**UTAH DEPARTMENT OF TRANSPORTATION**  
STANDARD DRAWINGS FOR ROAD AND BRIDGE CONSTRUCTION  
SALT LAKE CITY, UTAH

**PEDESTRIAN ACCESS**

**SUPPLEMENTAL DRAWING**

STD. DWG. NO.  
**PA 5**

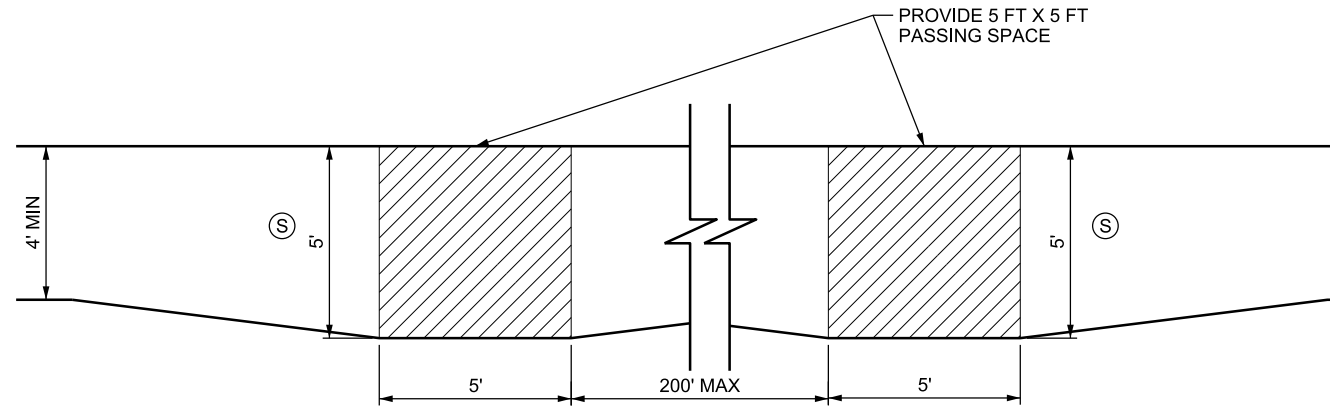
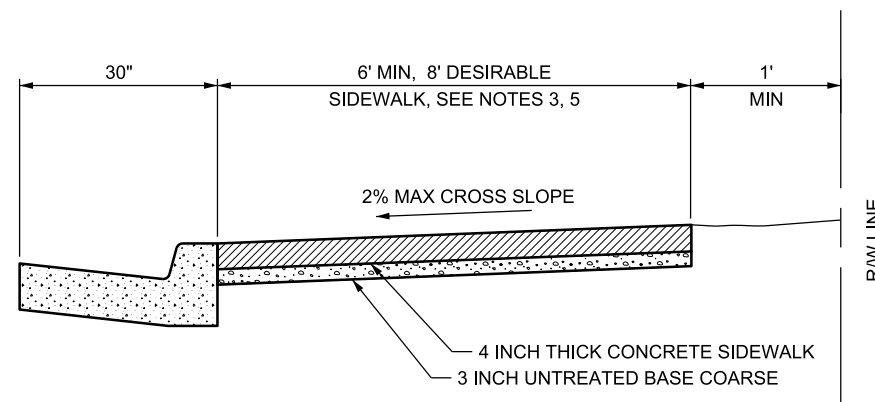
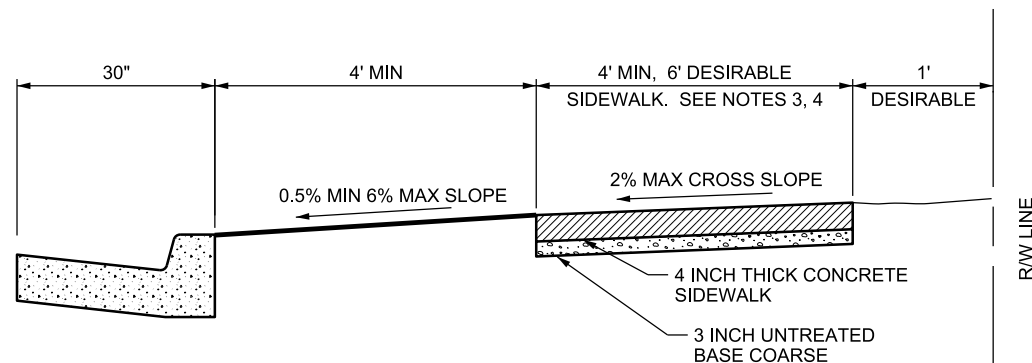
NO.	DATE	APPR.	REMARKS
1	04/06/2017	JBY	NOTE 3 CHANGED AND RENUMBERED. "DESIGN-ONLY" NOTE ADDED.

**DESIGN-ONLY NOTE**

A. DESIGN THE ITEMS IN THE SLOPE TABLE SHOWN ON PA 1 ACCORDING TO THE LISTED MAXIMUM OR MINIMUM VALUES.
